## **DDA Compliance Statement – Village Precinct and Car Park Section** **4.55 Modification – Concept / Schematic Phase**

### DDA COMPLIANCE STATEMENT

This accessibility and DDA compliance report is specific to Concept / Schematic Design Stage.  
A full listing of drawings and documentation pertinent to this report are attached in Appendix 1.

### Site Accessibility design intent

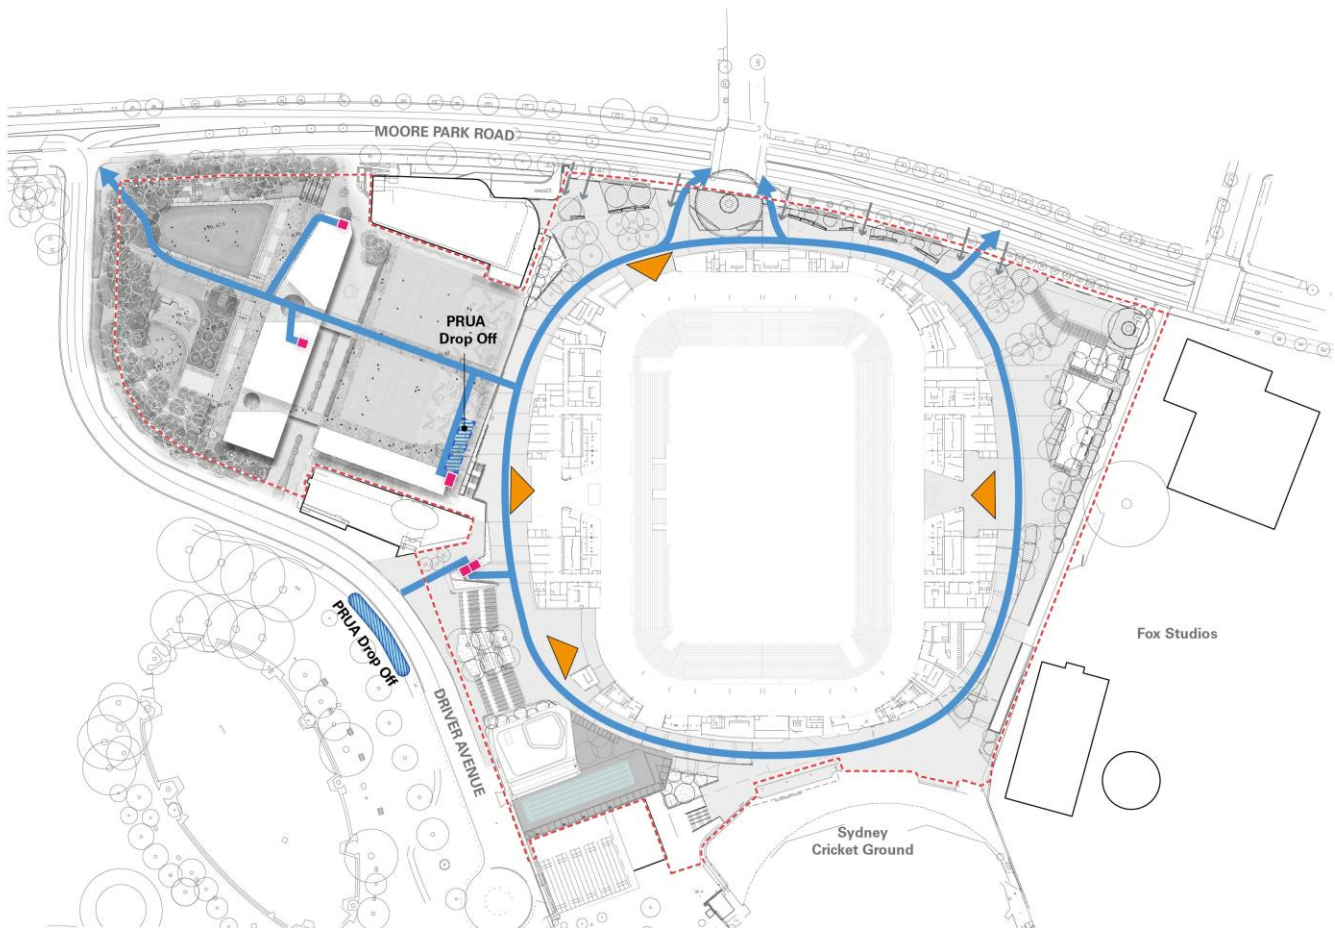
### Discussion:

A Person Requiring Universal Access (PRUA) drop off zone from Driver Avenue provides connecting pathways to the main stair and vertical travel via accessible passenger lifts for access to the Sydney Football Stadium and for access to the lift at the car drop off zone with connecting pathways linking to the Village Precinct and through to the corner of Moore Park Rd and Driver Avenue for compliant at grade pedestrian access to the site.

Passenger lifts provide connection to lower carparking levels within the Village Precinct for compliant accessible paths of travel.
